City of Bunnell, Florida

Agenda Item No. 4.

Document Date: 2/22/2025
Department: Community Development
Subject: SE 2023-08 Requesting a modification to an approved special exception for the Phoenix Crossings development.
Property Address: N Bay Street
Zoning Designation: L-1 / R-3B
Future Land Use Designation: Industrial / Multifamily
Agenda Section: New Business

Document Date: 2/22/2025
Department: Community Development
Subject: MJSP 2023-15 Requesting approval of the major site plan for the Phoenix Crossings project, located off of North Bay Street.
Property Address: N Bay Street
Zoning Designation: L-1 / R-3B
Future Land Use Designation: Industrial / Multifamily
Agenda Section: New Business

SHEET
C006

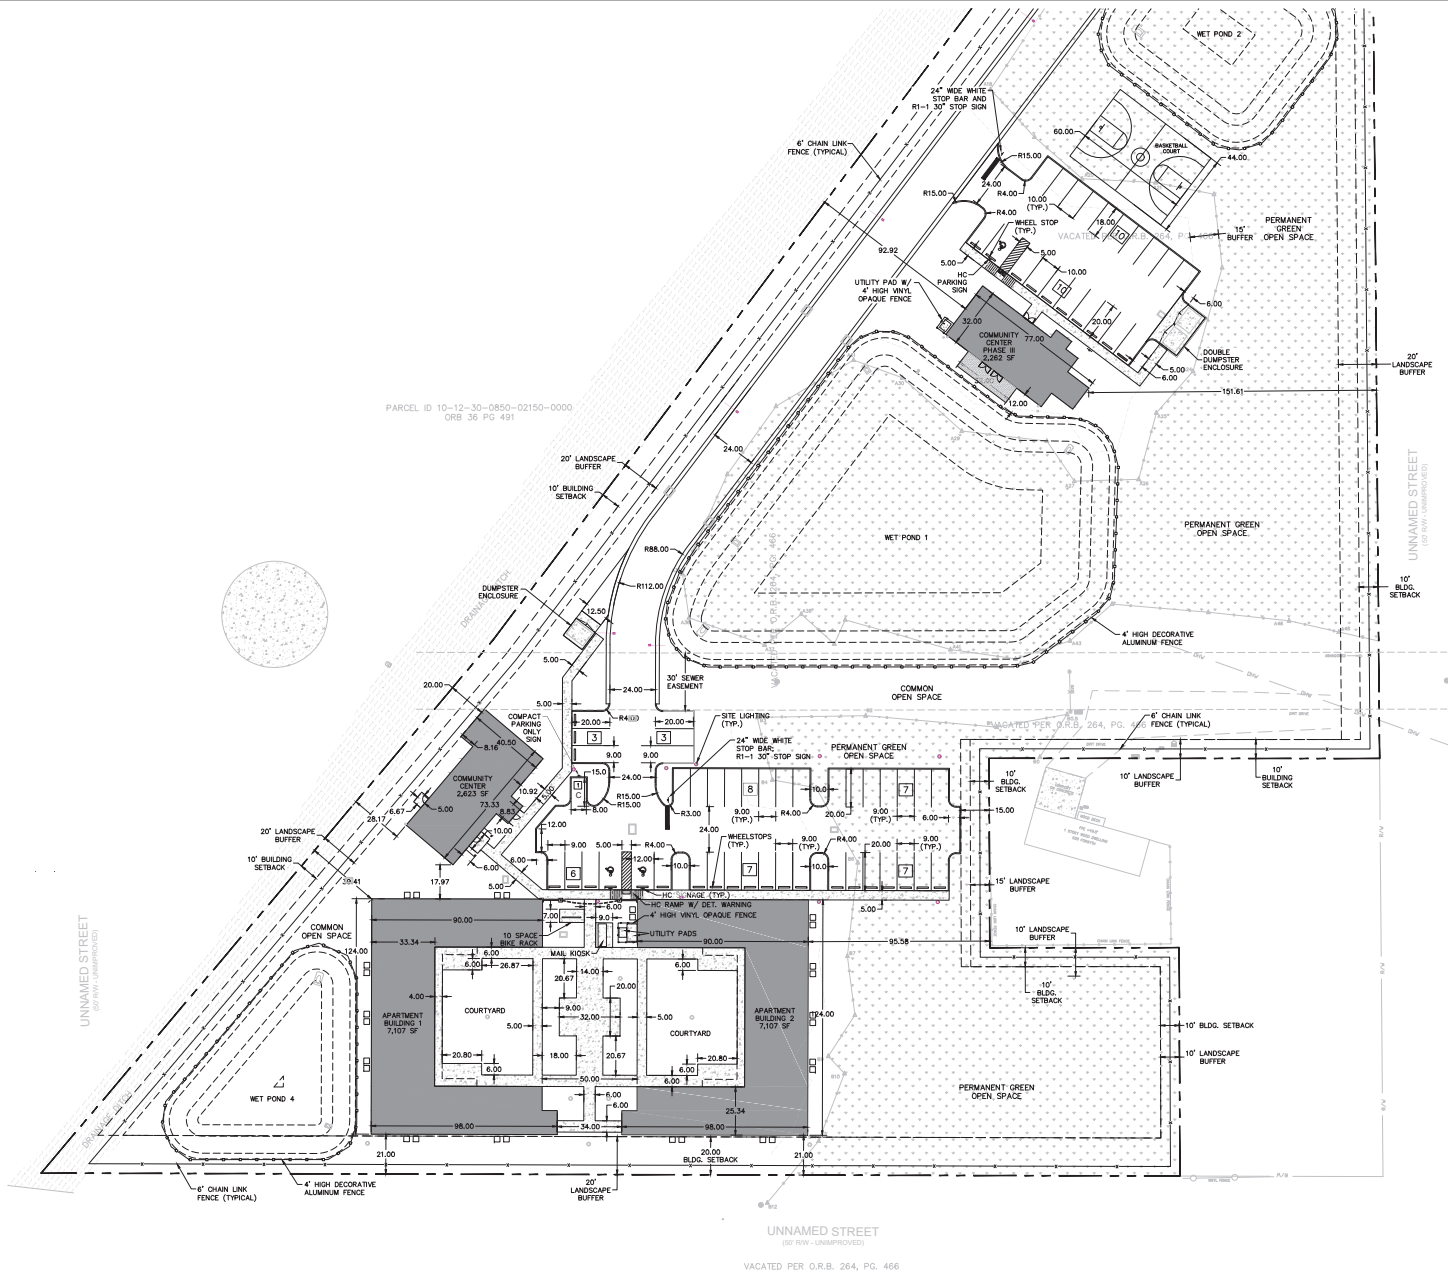
4. On sheet C006, the dead-end sign at the entrance point from Elkin Street into Phoenix Way was provided but was incorrectly placed on Elkin Street at the end of Elkin Street. Please place the dead-end sign within Phoenix Way and the entry point to Phoenix Way.
